**RE: Comments of Turner Ranch Properties, L.P. on the Draft Environmental Impact Statement for the Copper Flat Copper Mine**

**COMMENTS ON THE DRAFT ENVIRONMENTAL IMPACT STATEMENT FOR THE  
COPPER FLAT COPPER MINE**

**PREPARED BY THE NEW MEXICO ENVIRONMENTAL LAW CENTER (“NMELC”)  
ON BEHALF OF TURNER RANCH PROPERTIES, L.P. (“TRP”)**

Figure 1: Outline of Ladder Ranch property lines with the Copper Flat Mine and production wells (PWs). Turn Ranch Properties, L.P. developed the base map for this figure.

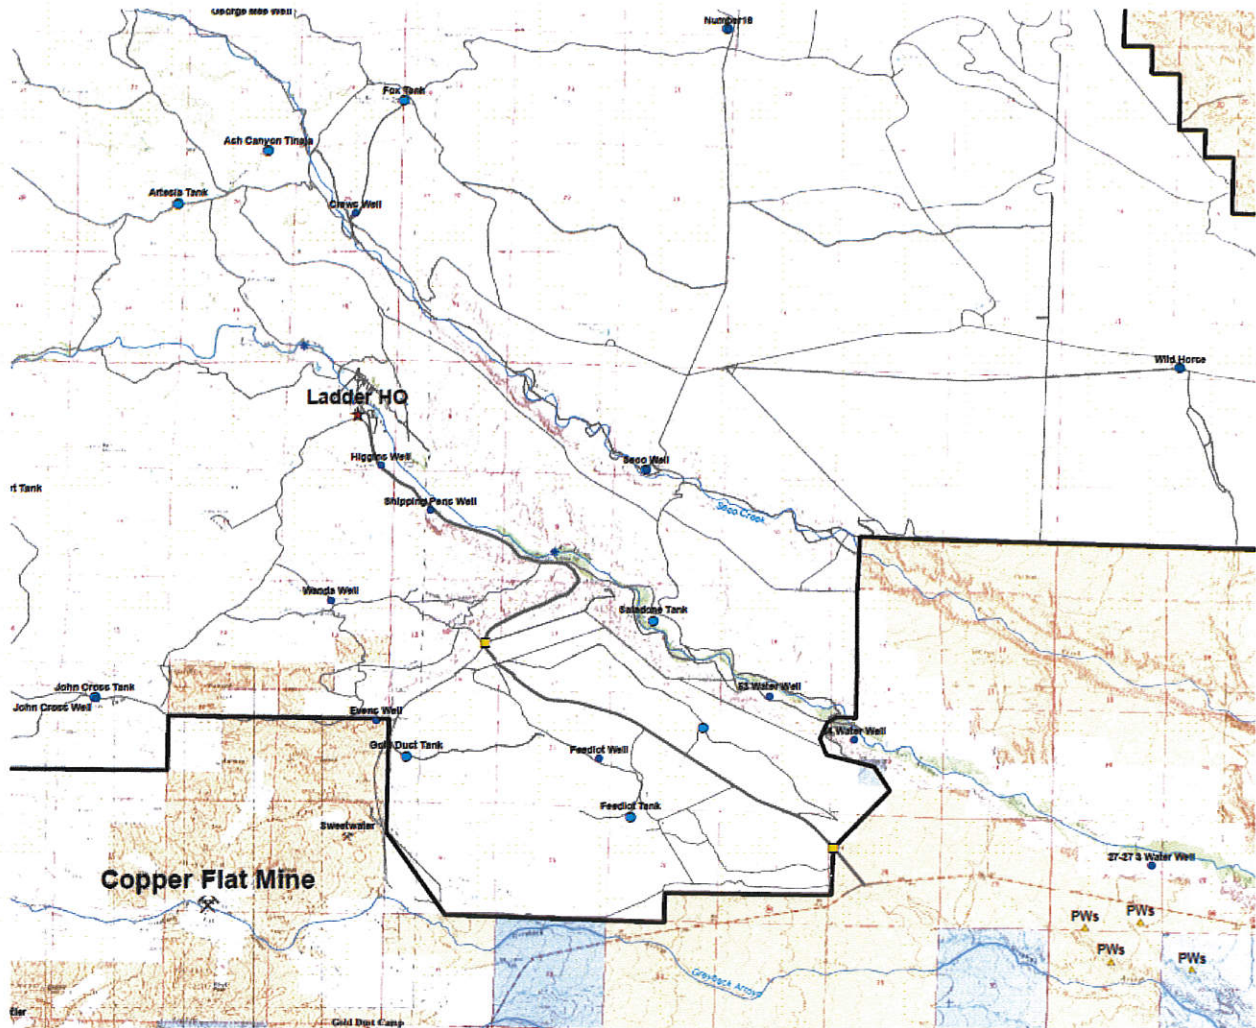
The DEIS model predicts that the one-foot drawdown under Las Animas Creek would extend about three miles beyond Ladder's southern boundary to about the Saladone Tank area (Figure 1). Drawdown under Las Animas Creek would be about 10 feet at Ladder's southern property boundary. This is an

**Figure 2: DEIS Figure 3-15a showing a hydrograph of flow loss rates for the proposed action. Similar hydrographs to Figure 2 are shown in the DEIS for all alternatives.**

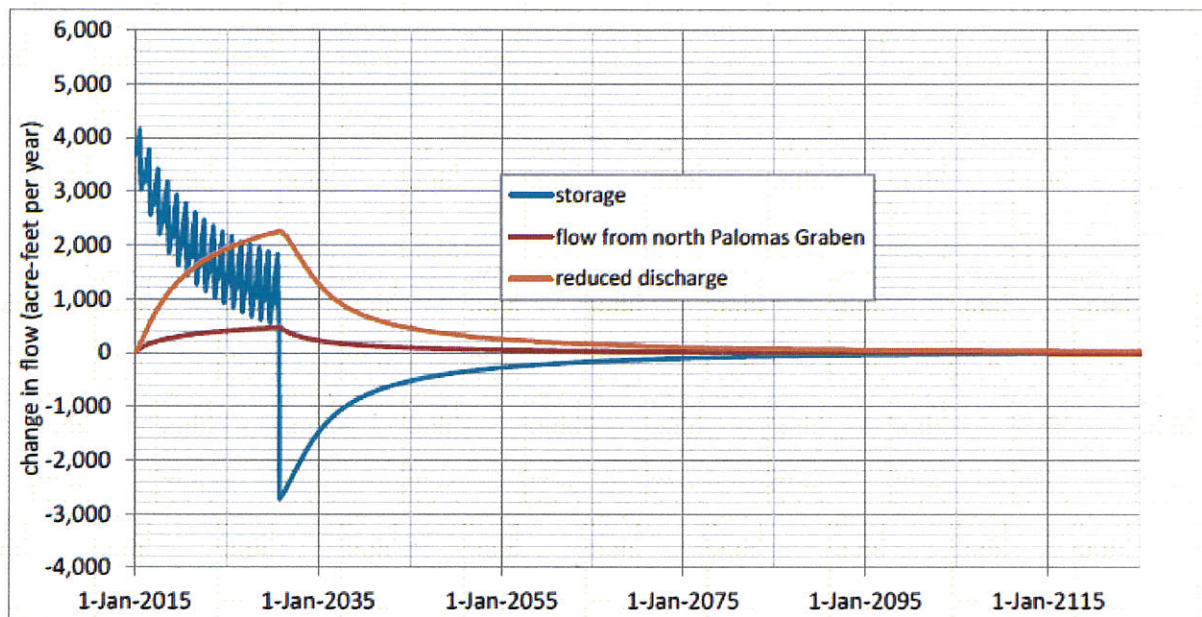
The maximum loss for all action alternatives rates (Figure 2) are about 0.2 to 0.3% of the total average flow from Caballo Reservoir. During drought, groundwater discharges to the river are the most consistent source of inflows to the reach because the valley aquifers are essentially additional storage for the river (Bureau of Reclamation 2013). For this reason losses to groundwater discharge will be much more important during drought periods. There have been years during which the average flow from the reservoir was about a quarter of the long-term average, so the reductions due to lost groundwater inflow can be as much as 1% of the total river flow at the Caballo Reservoir.

The modeling also allows groundwater to enter from the north into the graben (Figure 2). For example, up to 665 af/y was induced to enter the graben for Alternative 2 (Table 1). However, as discussed above, the DEIS does not disclose the source of this water from the north; the groundwater model simply models it as a boundary with unlimited available water without explaining its source (Jones et al. 2014). This additional flow to the graben prevents additional groundwater from being removed from groundwater storage, which would cause additional drawdown. This unreasonable assumption also fails to account for groundwater that would not be discharged to surface water, which would in turn prevent accounting for further decrease in flows to the Rio Grande.

**Figure 3: DEIS Figure 3-13b showing drawdown in model layer 2 at the end of mining for the Proposed Action.**

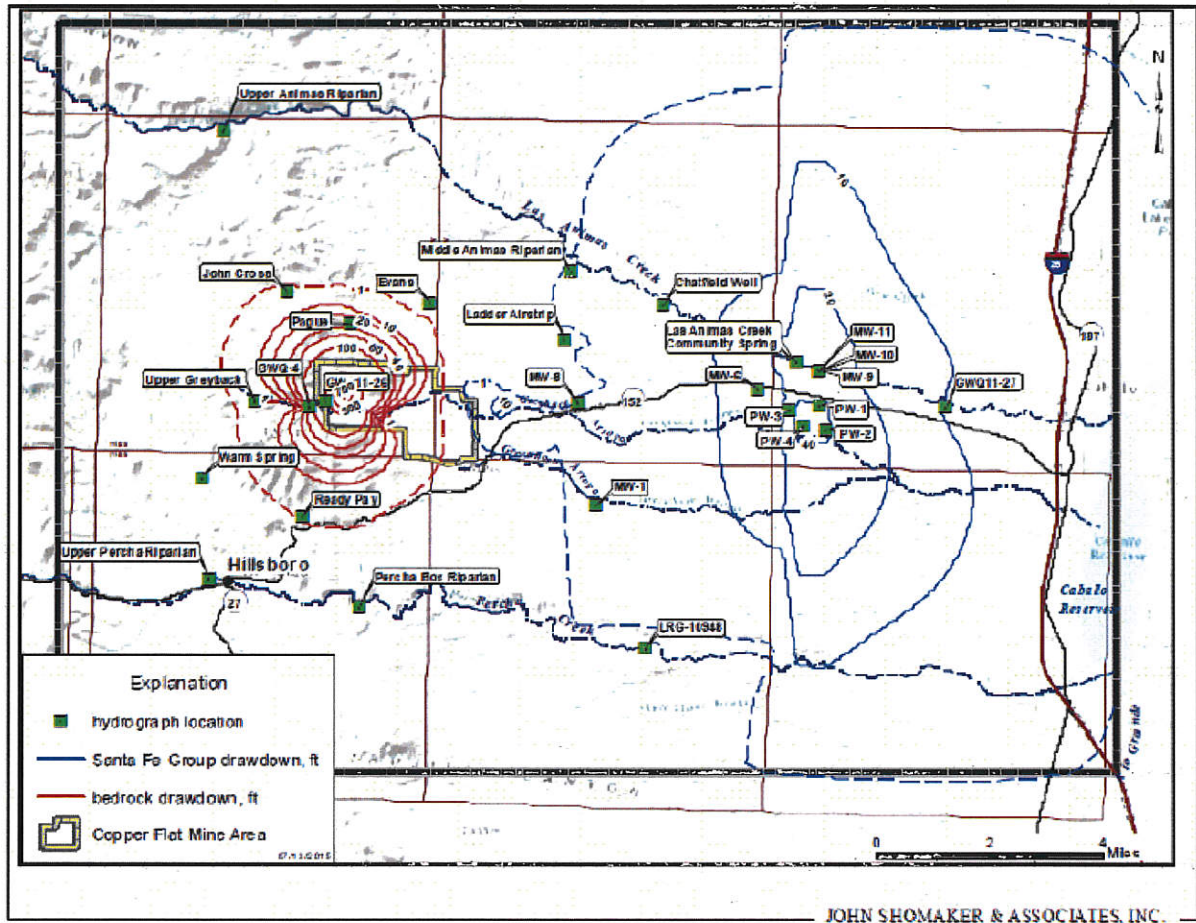
The drawdown cone caused by the Mine's production well pumping (Figures 3 and 4 show DEIS Figure 3-13b and 3-15b for the Proposed Action and Alternative 2, the Preferred Alternative, respectively) shows minimal drawdown at Caballo Reservoir; the dashed contour intersects the reservoir. The reservoir prevents the groundwater from drawing down at the reservoir because the reservoir adds water to the groundwater model domain. The groundwater model uses a boundary for the reservoir which, in the modeling, sets the water level. Drawdown affects the reservoir by diverting groundwater flow from

Figures 3 and 4 show that drawdown contours are elongated north-south parallel to the reservoir. This is due to biases coded into the modeling, as discussed in detail in the conceptual model and numerical modeling sections below. The biases are due to how the models establish the properties of the Palomas Graben, the geologic feature in which the Mine's production wells are located. The models assume the Palomas Graben is a north-south trending feature with transmissivity much higher than the surrounding aquifer, a conceptualization not supported by data. The models also assume that faults bound the graben on the east and the west, with the fault on the west being almost impervious.

The drawdown cone at the Mine pit (Figure 3) is much deeper than that at the production wells for all action alternatives (Figures 3 and 4), but represents much less water removed from storage due to the much lower porosity in the bedrock around the pit. After mining, a small pit lake will form and evaporate water in perpetuity. This evaporation will cause the pit to hydraulically resemble a large diameter well in perpetuity. The DEIS discloses the evaporation rate for the Proposed Action will be about 100 af/y (DEIS p 3-76), but does not disclose the evaporation rate for Alternative 2, which will be larger because the pit is larger. Pit lake evaporation is a permanent loss of flow to the Rio Grande, although it will not manifest at the river for a very long time due to travel time between the pit and river.

**Figure 9: Figure 8-14 from INTERA (2012) showing actual 2011 groundwater contours.**

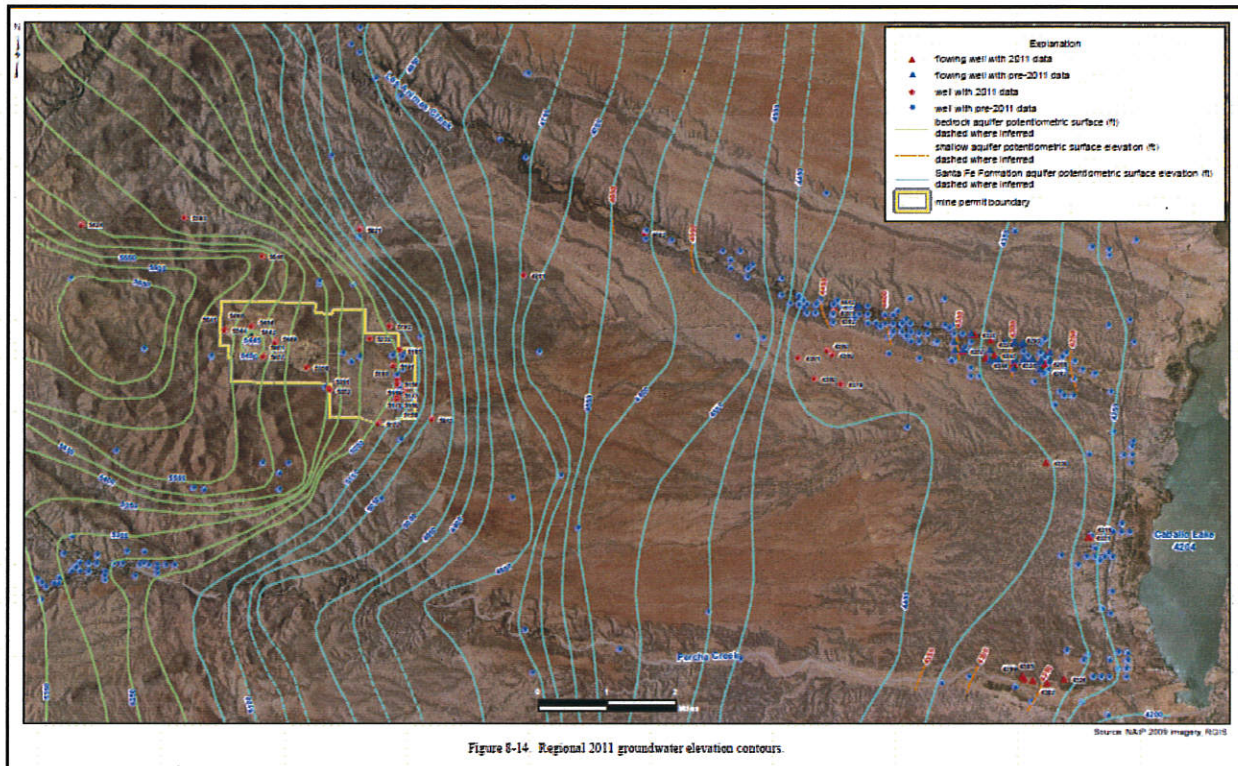
**Groundwater Contours:** The groundwater contour map, INTERA Figure 8-14 (reproduced as Figure 9 herein) shows a west to east gradient through the study area, with contours affected by topography, aquifer permeability, and the elevation of discharge points (such as the river and creeks). Low permeability in the Animas uplift generally, and the andesite around the Mine, diverts groundwater flow from the west around the pit area north and south to Las Animas Creek and Percha Creek, as indicated by the mounding (Figure 9). INTERA suggests that the groundwater mound shows how the andesite diverts groundwater into the creeks. There are springs in the upper part of Las Animas Creek that could result from flow diverted northward, but the springs could also result from local recharge in the graben (the area of which INTERA Figure 8-12 indicates is much larger in the Las Animas watershed). Understanding these flow paths is essential to modeling and predicting the effects of the Mine, but INTERA falls far short of supporting its hypothesis.

The groundwater contour map (Figure 9) shows a substantial west to east gradient through the andesite and Mine area that could reflect more groundwater flow than accounted for by INTERA (and the DEIS). If the analysis is wrong, there can be substantially more dewatering for the pit than estimated. Its effects on the drawdown cone will depend on aquifer properties. The DEIS simply does not have adequate hydrogeologic data to support its conclusions regarding the effects of dewatering. The wells are not deep enough to provide sufficient data concerning the properties at depth.

The groundwater contour map (Figure 9) also does not support other ideas presented by INTERA and assumed in the CFM:

- There is no evidence that faults are flow barriers. A flow barrier would cause a steplike shape in the contours, which is not present in Figure 9.
- The contours do not indicate flow from the north enters the study area domain, as INTERA (and Jones et al. 2012) suggest occurs.

**Figure 11: Snapshot of a section of a portion of Figure 8-17 (INTERA 2012). The figure shows a section west-east through the existing tailings impoundment, including a sulfate plume emanating from the tails.**

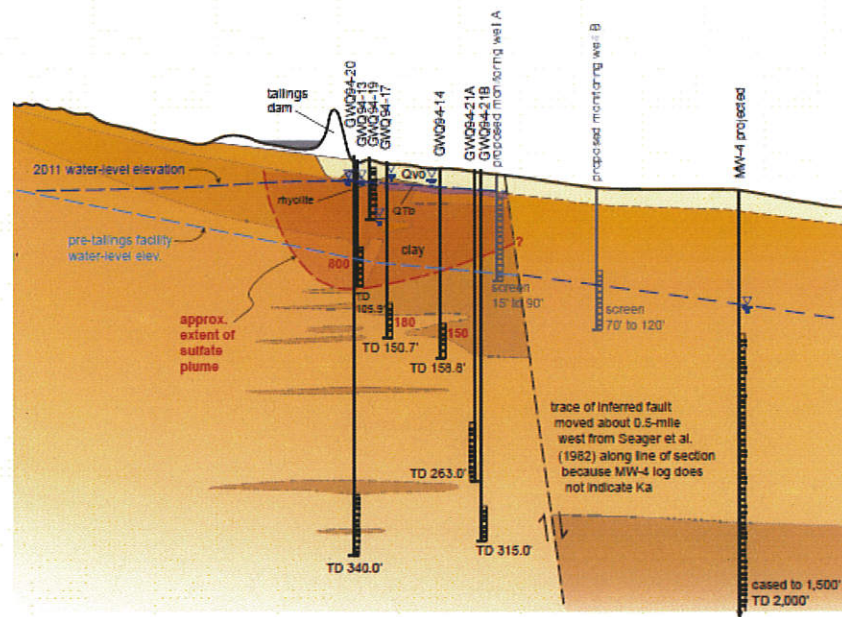
The cross-section figure also misrepresents the vertical extent of the plume. Wells GWQ94-21A and -21B are beneath the plume, but have sulfate concentrations at 120 mg/l. Even the deeper well GWQ94-20 has concentrations as high as 56 mg/l, although the last observation was in 1996. It should have been sampled during the baseline sampling period to estimate whether its concentration has increased. If the fault prevents or limits eastward flow and there is a mound under the tails, it is likely there is a downward gradient beneath the tails and west of the fault. A downward gradient would drive downward vertical flow so that contaminant advection and vertical dispersion could cause sulfate concentrations to increase at depth.

**Figure 12: Portion of Figure 5, JSAI (2013), showing groundwater contour details near the existing tailings impoundment.**

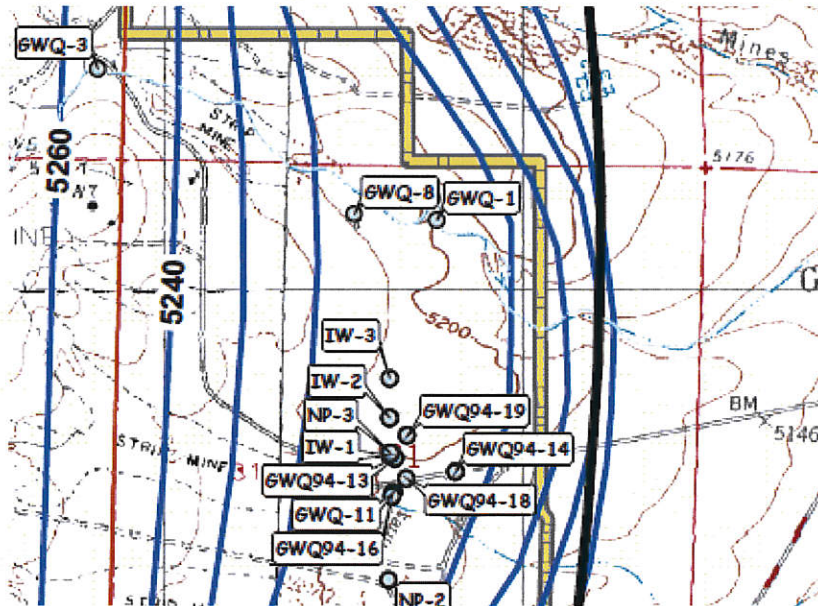
The contours in JSAI Figure 5 show crenulations that would exist if the groundwater elevation was higher and groundwater actually discharged into the alluvium, but there is no well data to support the placement of these crenulations. The alluvium of Grayback Arroyo could act as a hydraulic drain, but the referenced Figure 6 does not provide evidence in support of that. JSAI states that downgradient of GWQ-1 (east of it) the “hydraulic gradient steepens as a result of the barrier boundary effect of the East Animas Fault Trend.” *Id.* Figure 12 contained herein, is a snapshot of a portion of JSAI (2013) Figure 5, and shows the steepened contours between GWQ-1 and the fault, but fails to show monitoring wells to support the location of the contours. In fact, if the fault is a barrier, the groundwater table west of it will be flat due to a backwater effect, just as water ponds upstream of a dam. The steep gradient will occur as a change across the fault, not on one side of it.

Incidentally, the various reports have different locations for the East Animas Fault. JSAI (2013) shows the fault east of the east property boundary, whereas Jones et al. (2013) show the fault as much as half a mile further west, albeit as inferred (Figure 4.3, Jones et al. 2013); the same figure shows another fault just east of the property line in roughly the same location as the East Animas Fault in JSAI (2013). Discussion on JSAI (2013) page 18 suggests there is a difference of opinion regarding the exact location.

Figure 14: Figure 6.3 (Jones et al. 2014) showing layer 2 hydrogeologic zones.

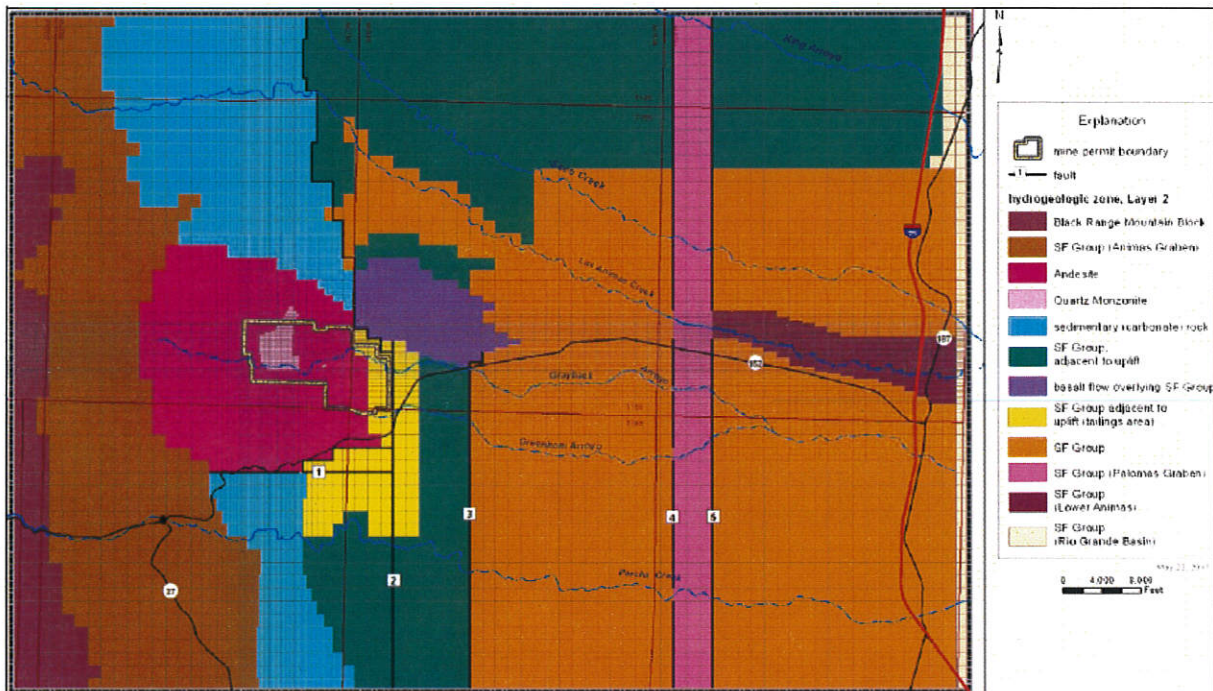
Figure 14, herein, also shows the location of faults simulated in the DEIS model; and Jones et al. Table 6.2 shows the conductivity values used to determine the conductance for the horizontal flow barrier ("HFB") model, which is used to simulate the faults. The groundwater contour maps suggest very strongly that the groundwater model simulates the faults as being far more effective as flow barriers than the data actually justifies.

drops that could be assigned to faults (Figure 14) that is at all similar to the simulated effect (Figure 16). The actual groundwater contours do not suggest the faults are barriers as conceptualized by Jones et al. (2013, 2012).

**Figure 15: Screen capture of layer 2 from the Jones et al. model showing the plan view (below) and cross-section above. The figure is from the steady state model files.**

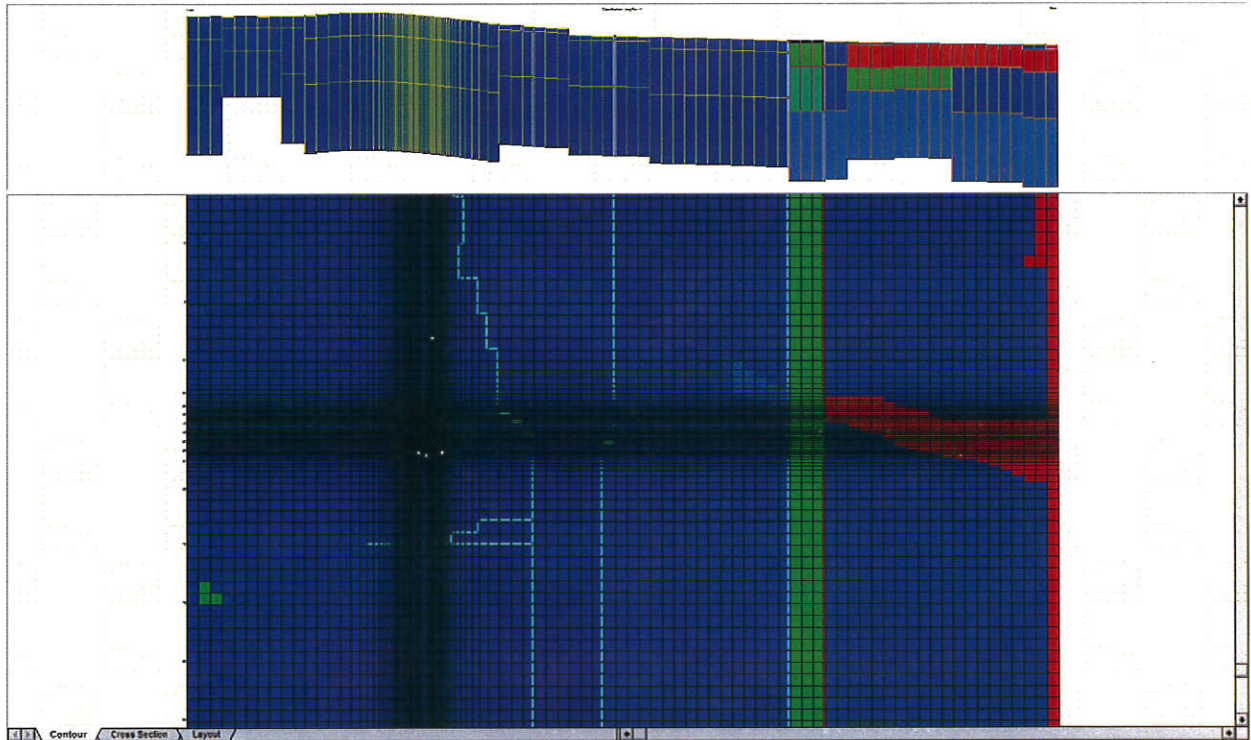
The variable thickness for layer 2 near the Palomas Graben is the most significant. At 10 ft/d (feet per day), the graben has one of the higher conductivity values for the Santa Fe group. Layer 2 thickness increases from 500 to 1,000 feet from west to east across the transition into the Palomas Graben (Figure 14). This causes the transmissivity to increase from 900 to 10,000 ft<sup>2</sup>/d<sup>5</sup> from west to east across the transition. Production pumping occurs from the graben.

**Figure 16: Figure 6.11 from Jones et al. (2013) showing simulated steady state groundwater contours. The red line approximately midway north/south through the map is Hwy 152. The label “simulated 2012 groundwater levels appears to be incorrect in the original document.**

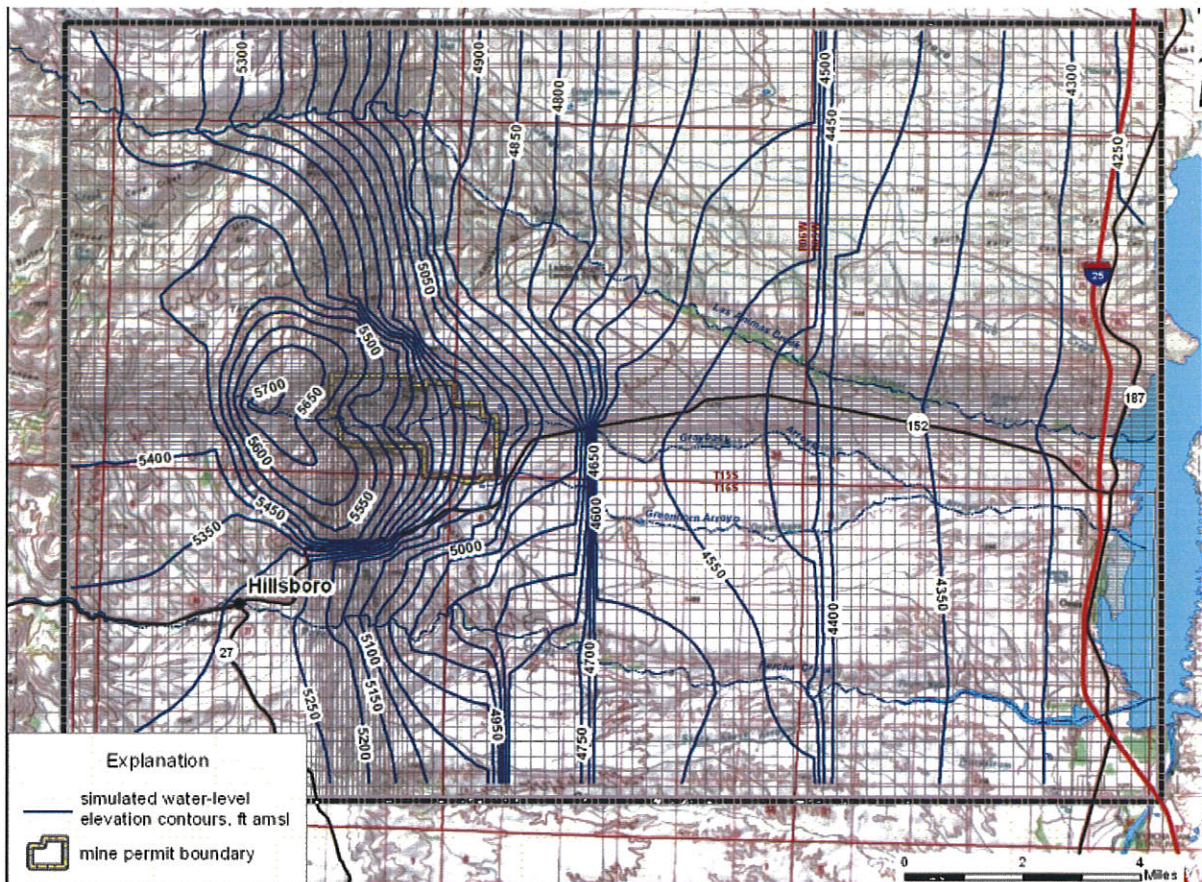
Figure 16, herein, shows the simulated steady state contours from Jones et al. (2013) Figure 6.11 (the figure is labeled "simulated 2012 groundwater levels" contrary to how the text in Jones et al. refers to it). Due to 30 years of inactivity there will not be a significant difference. Figure 9 (shown above) is the 2011 groundwater contour map from INTERA (2012) Figure 8-14. There are many differences between these two groundwater contour maps, but the most glaring difference is the lack of significant contour

Conductance for the fault on the west side of the Palomas graben is  $1 \times 10^{-8}$  ft/d, while on the east side is 1, an order-of-magnitude difference of 8. The amount of water crossing the fault on the west will be miniscule and therefore the fault effectively isolates the model on the west from the model on the east. The simulated steady state contour map (Figure 16) shows two locations with significant head drops, as expected due to low conductance faults. The easternmost drop of from 150 to 200 feet coincides with fault 4 (Figure 16, see fault numbers in Figure 14), the west side of the Palomas graben. Faults 4 and 5 both have a gap at Las Animas Creek, which does not seem justified by the geology because the fault is not in the alluvial formation in layer 1. This gap will concentrate flow from west of the fault into the formation beneath the creek, where it will be available to replenish the creek or prevent drawdown.
